Attachment 2– Residential Flat Design Code.

Building Separation:

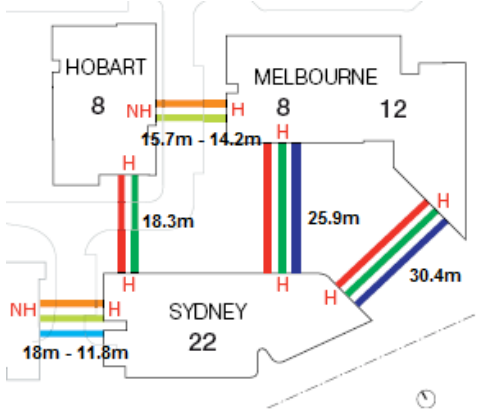
8	building heights in storeys				
H / NH	habitable / non-habitable area				
H / H	habitable / habitable area				
LEVELS 1- 4	<table border="0"> <tr> <td></td> <td>min. 9 m bldg separation (NH - H)</td> </tr> <tr> <td></td> <td>min. 12 m bldg separation (H - H)</td> </tr> </table>		min. 9 m bldg separation (NH - H)		min. 12 m bldg separation (H - H)
	min. 9 m bldg separation (NH - H)				
	min. 12 m bldg separation (H - H)				
LEVELS 5-8	<table border="0"> <tr> <td></td> <td>min. 13 m bldg separation (NH - H)</td> </tr> <tr> <td></td> <td>min. 18 m bldg separation (H - H)</td> </tr> </table>		min. 13 m bldg separation (NH - H)		min. 18 m bldg separation (H - H)
	min. 13 m bldg separation (NH - H)				
	min. 18 m bldg separation (H - H)				
LEVELS 9 storeys +	<table border="0"> <tr> <td></td> <td>min. 18 m bldg separation (NH - H)</td> </tr> <tr> <td></td> <td>min. 24 m bldg separation (H - H)</td> </tr> </table>		min. 18 m bldg separation (NH - H)		min. 24 m bldg separation (H - H)

Where separation distances are less than the distances prescribed ie between Hobart and Melbourne Buildings and Sydney and Brisbane (Stage 1) Buildings have been reviewed by URDP and privacy screens have been provided - adequate daylight access, urban form and visual and acoustic privacy

No – but consistent with approved Concept Plan. Areas of non compliances

<p>has been achieved.</p> <ul style="list-style-type: none"> • Privacy screens provided on the eastern elevation of Hobart Building which faces the western elevation of Melbourne Building. • Privacy screens on the eastern elevation of Brisbane Building to minimise impact to the western side balconies of Sydney Building. 	
<p>Street Setbacks Identify the desired streetscape character. In general, no part of the building should encroach into a setback area.</p>	<p>Consistent with Concept Plan Approval MP10_0112. Concept Approval Report: <u>Eastern boundary (Melbourne)</u> – 5m. Proposed: 5m <u>Southern boundary (Sydney)</u> 10m & 7m. Proposed: 10m and 7m. <u>Northern boundary (Hobart & Melbourne)</u> 16.1m Proposed: 16.7m Hobart. 19m Melbourne.</p>	Yes
<p>Side and Rear Setbacks Relate side setbacks to existing streetscape patterns. These controls should be developed in conjunction with building separation, open space and deep soil zone controls. In general, no part of the building should encroach into a setback area.</p>	<p>Consistent with Concept Plan Approval MP10_0112 as modified.</p>	Yes
